# SERVICE BULLETIN

No. 546

Piper Aircraft Corporation

Inspection of Whelen Wing Tip Strobe Lights;  
Reference F.A.A. Airworthiness Directive  
75-05-04

WHELEN NAVIGATION AND STROBE LIGHT ASSEMBLY

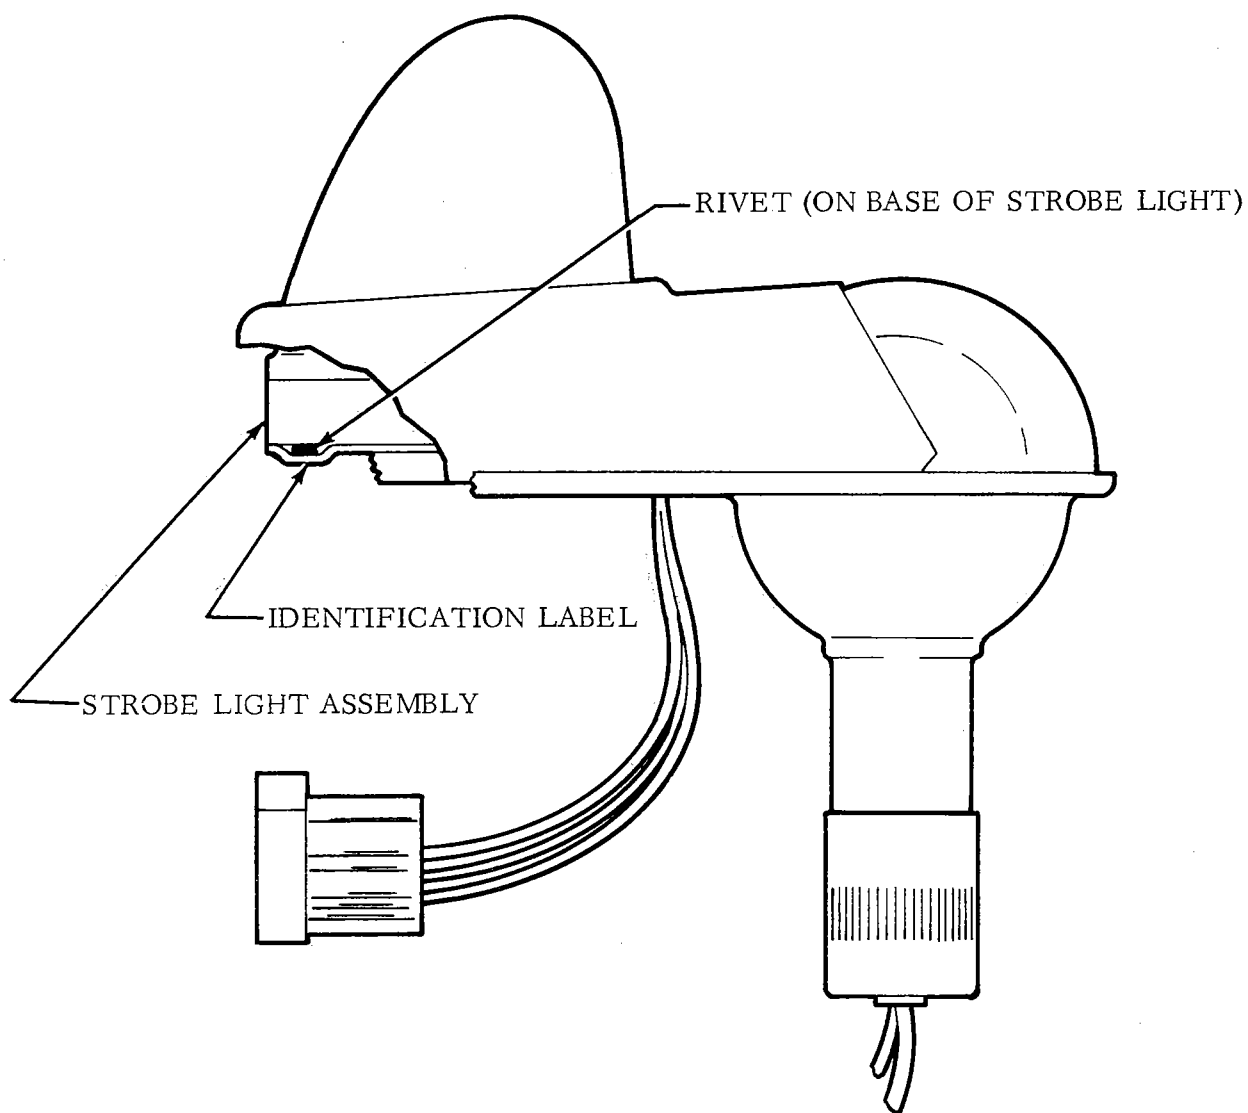
1. Expose wing tip strobe light assembly to view (refer to attached sketch for a typical strobe light assembly illustrated view).
2. If the following modification has already been accomplished, no further action is required; make appropriate entry in aircraft log book re compliance with this Service Release.

3. If the following modification has not been accomplished, proceed as follows:
  - a. Install on the base of the Whelen A-427 Flash Tube Assembly a pressure sensitive vinyl label conforming to Whelen drawing no. A-30052, Revision 1 dated October 15, 1974 or later F.A.A. approved revision.

1. Scotch Brand Type 33+ Vinyl Plastic electrical tape or equivalent tape - approved by an F.A.A. Maintenance/Avionics Inspector may be used in lieu of the vinyl label (if any plastic tape is used, it must be formed to cover the rivet at the rear of the flash tube without covering the identifying part number).

3. b. If the flash tube incorporates a label, the new label or tape may be installed directly over the old label.
- c. Install label or tape only when the label or tape and the flash tube are at a temperature above 50 degrees F.
4. Make appropriate service release compliance entry in aircraft log book.
